REMEDIATION SYSTEM EVALUATION

MIDLAND PRODUCTS SUPERFUND SITE YELL COUNTY, ARKANSAS

Report of the Remediation System Evaluation,
Site Visit Conducted at the Midland Products Site
February 27, 2001

Final Report Submitted to Region 6
June 4, 2001

FIGURE 1-1. SITE LAYOUT SHOWING THE POTENTIOMETRIC SURFACE FROM SEPTEMBER 2000, 1990 ESTIMATED CONTAMINANT PLUME, AND WELLS WITH AND WITHOUT CONTAMINATION BETWEEN SEPTEMBER 1994 AND SEPTEMBER 2000.

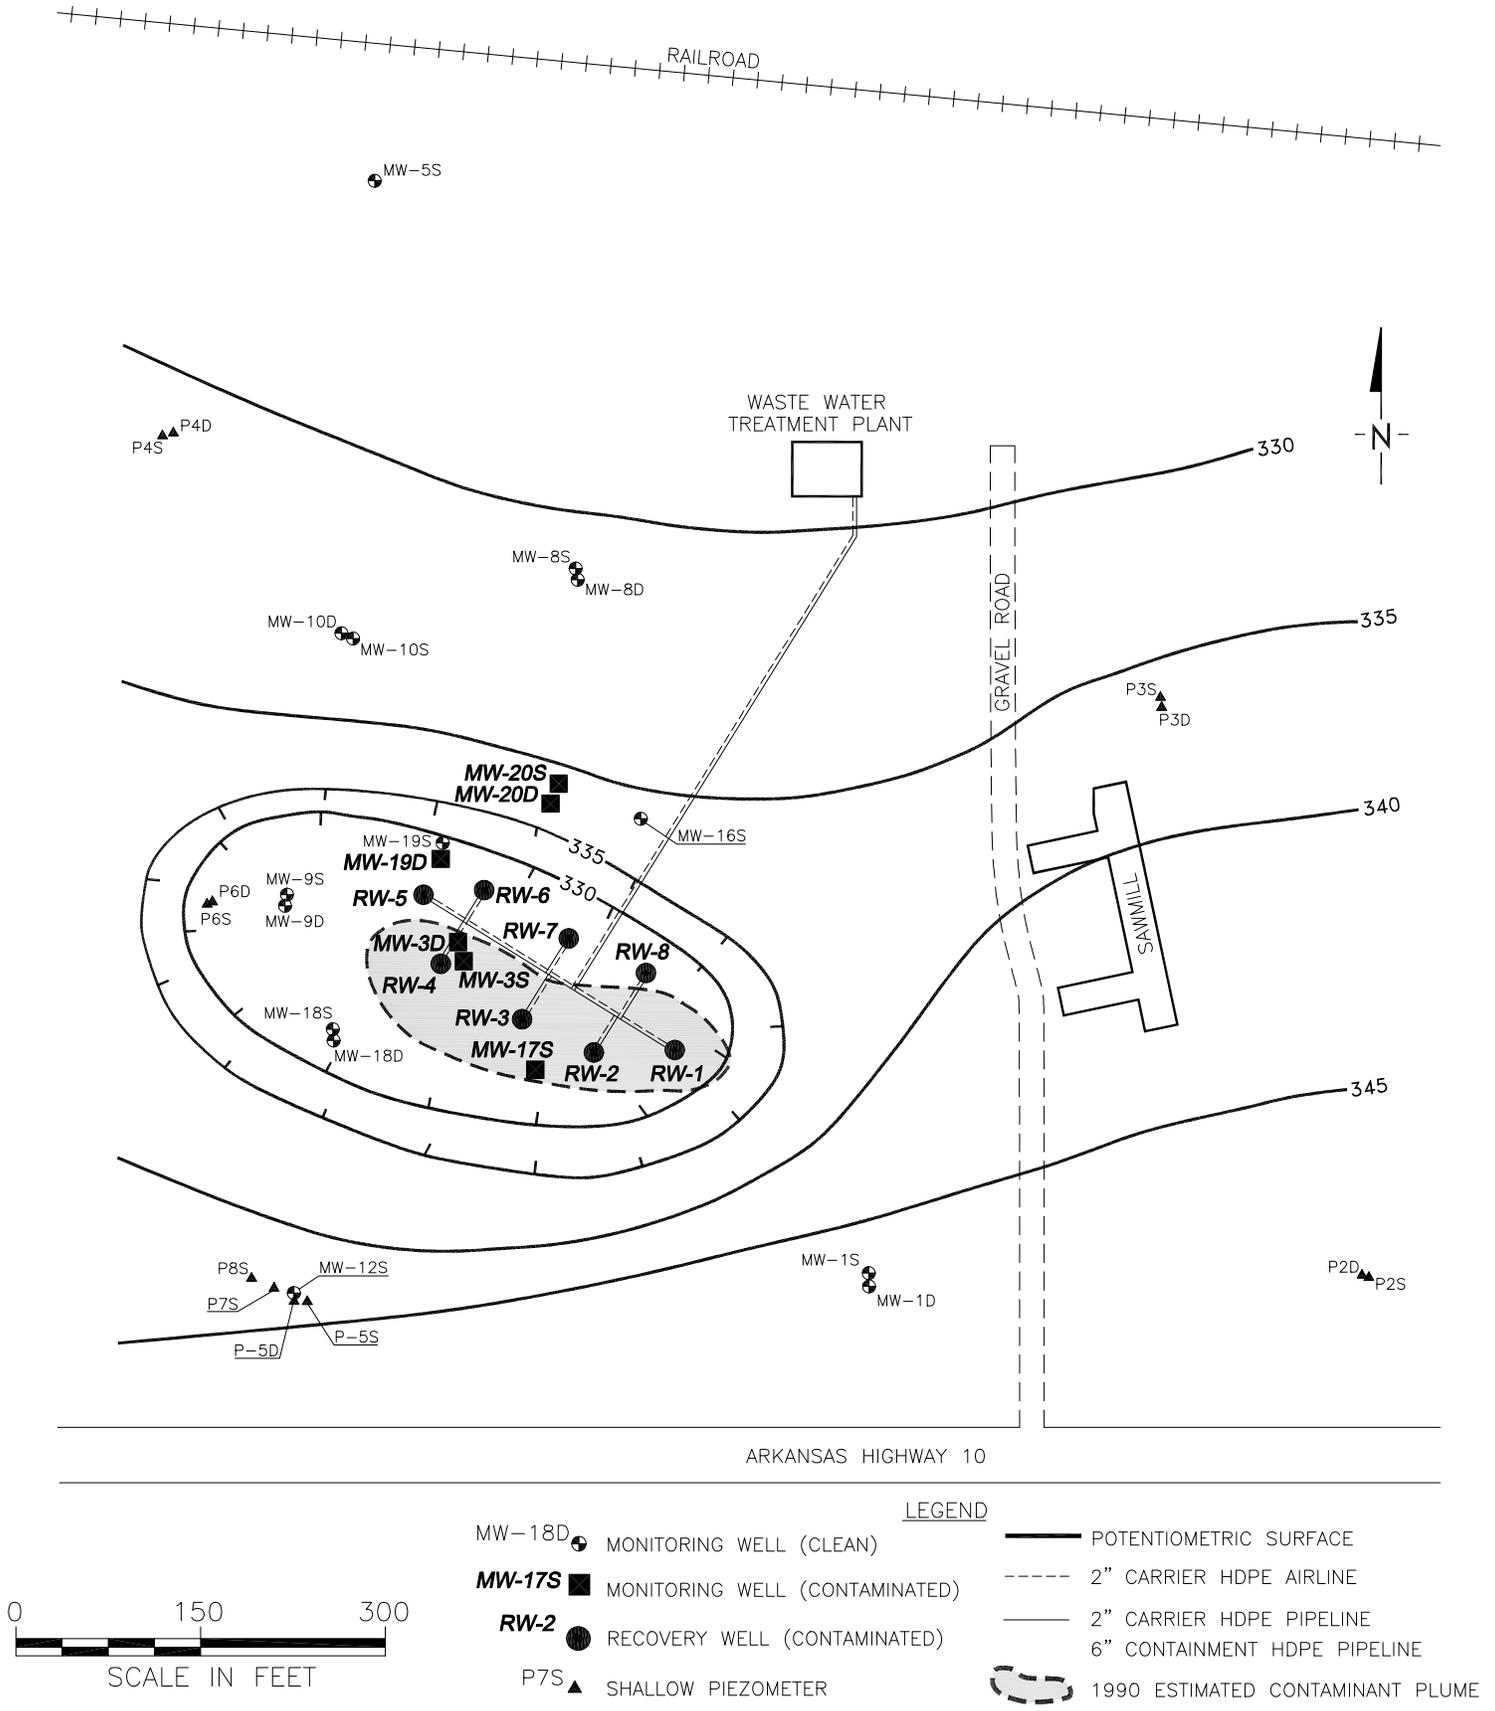
Samples from monitoring and recovery wells within the capture zone have detectable concentrations of PCP and PAHs. However, downgradient of the capture zone there are only three pairs of monitoring wells, the closest of which is 100 to 150 feet from that zone. As a result, plume delineation is somewhat vague. Furthermore, while capture zones are plotted each month as part of the sampling report, the lack of plume delineation prevents a clear understanding of the containment offered by the pump-and-treat system and the possibility of contaminant migration.

The RSE team, therefore, recommends adding five new monitoring wells down gradient of the plume. Referring to Figure 1-1,

- one deep well (approximately 40 feet deep) with a screened interval of 5 to 10 feet should be added near MW-16s in order to sample the unweathered bedrock in this area,
- two wells, one shallow well (approximately 20 feet deep and screening 5 to 10 feet of the weathered bedrock) and one deep well (approximately 40 feet and screening 5 to 10 feet of the unweathered bedrock) should be added 50 feet due north of MW-20s and MW-20d, and
- two wells, one shallow well (approximately 20 feet deep and screening 5 to 10 feet of the weathered bedrock) and one deep well (approximately 40 feet and screening 5 to 10 feet of the unweathered bedrock) should be added midway between the MW-10 and MW-20 monitoring well couplets.

These wells should be sampled quarterly for PCP and PAHs for one year, and semi-annually with the other monitoring wells thereafter. This would significantly improve plume delineation down gradient of the original source area. Over the lifetime of the pump-and-treat system, these wells would ensure containment, and upon potential shut down of the system, they would signal whether or not the remaining contaminants would migrate off site. Installation of these wells is estimated to cost less than \$5,000 each for a total capital cost of \$25,000. Laboratory analysis for the semi-annual sampling would cost approximately \$3,000 per year. If PCP and PAHs are detected during drilling of these wells or subsequent sampling, additional wells and sampling may be required.
